UNITED STATES **NM OIL CONSERVATION**
DEPARTMENT OF THE INTERIOR **ARTESIA DISTRICT**
BUREAU OF LAND MANAGEMENTFORM APPROVED
OMB NO. 1004-0135
Expires: July 31, 2010**SUNDRY NOTICES AND REPORTS ON WELLS**
*Do not use this form for proposals to drill or to re-enter an abandoned well. Use form 3160-3 (APD) for such proposals.*5. Lease Serial No.
NMNM81586

8. Well Name and No.
CEDAR CANYON 23 FEDERAL 4H9. API Well No.
30-015-43281-00-X110. Field and Pool, or Exploratory
PIERCE CROSSING11. County or Parish, and State
EDDY COUNTY, NM**SUBMIT IN TRIPLICATE - Other instructions on reverse side.**

OXY USA Inc. respectfully requests approval for the following changes to the approved permit:

Batch drill the Cedar Canyon 23 Federal #4H and Cedar Canyon 23 Federal #5H with skidding operations

Wellhead for pre-set surface casing.pptx

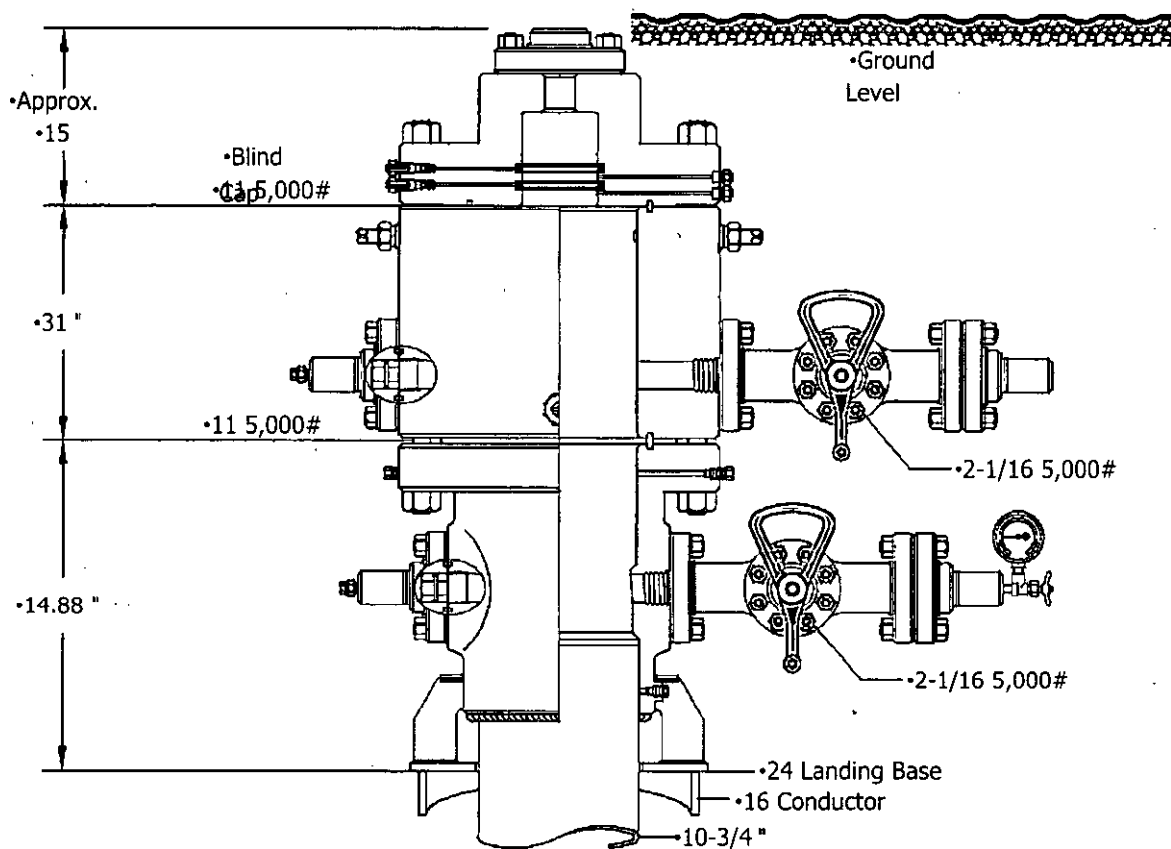
We will use a blind cap to prevent anything from falling into the well and between skids to secure it.

The operator has proposed to drill multiple wells utilizing a skid/walking rig. Operator shall secure the wellbore on the current well as proposed after installing and testing the wellhead, by installing a blind flange of like pressure rating to the wellhead and a pressure gauge that can be monitored while drilling is performed on the other well.
